CALIFORNIA COASTAL COMMISSION

**W 20b****STAFF REPORT AND RECOMMENDATION****ON CONSISTENCY CERTIFICATION**

Consistency Certification No.	CC-074-05
File Date:	6/7/2005
3 Months:	9/7/2005
6 Months:	12/7/2005
Staff:	LJS-SF
Commission Meeting:	11/16/2005

APPLICANT: California Department of Transportation**PROJECT LOCATION: State Highway 1 crossing of Ten Mile River, ten miles north of Ft. Bragg, Mendocino County (Exhibits 1-4)****PROJECT DESCRIPTION: Construct new Ten Mile River Bridge seismic replacement project and demolish existing bridge****EXECUTIVE SUMMARY**

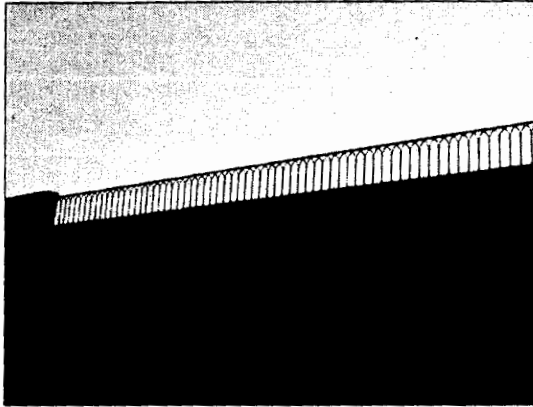
The lack of sidewalks goes against the commission's support for the California coastal trail. This bridge will be part of coastal trail and should provide for safe pedestrian use.

The Greenwood Bridge is near the town of Elk and is used by local citizens. Lack of a sidewalk endangers pedestrians.

Why a two-rail system with the ST-10?

1. National safety standards (the "AASHTO" standards) subscribed to by California say that pedestrians on bridges shall be protected from vehicles when the highway is designed for high speeds (50 MPH or greater). This protection requires a traffic barrier on the traffic side of the sidewalk.

- **Curved and arched elements should be explored, in order to make the rail design as graceful and attractive as possible.**
- **Because of the loss of many historic and attractive bridges throughout California, a new rail design should seek to incorporate elements of historic bridges where consistent with modern safety standards.⁴**

A pedestrian railing could easily incorporate curved arches that would reflect the arches that were incorporated into railings of the historic arched, concrete

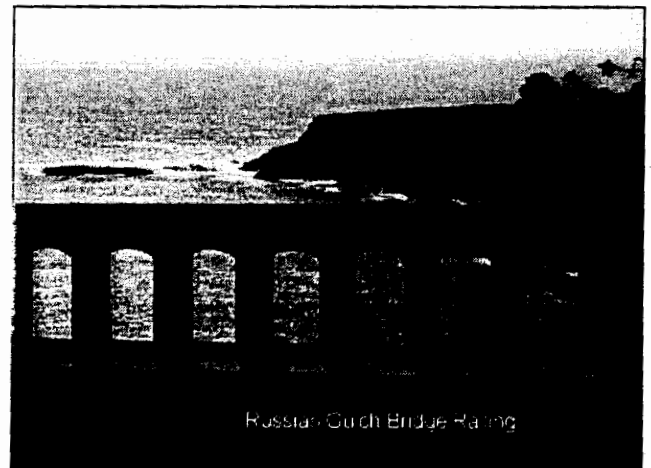
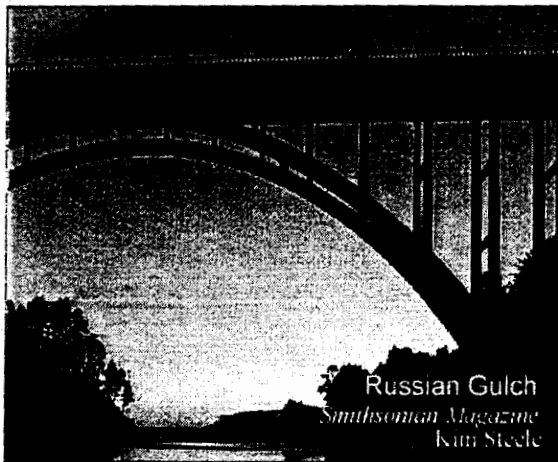
bridges of Highway 1. They would provide a link to the historic past. They would provide a feeling of tradition, as well as aesthetic beauty. Examples of such railings are shown below.

These railings are on bridges in France and are of cast iron. Alternative materials could be used, although cast iron would be structurally adequate for pedestrian railings.
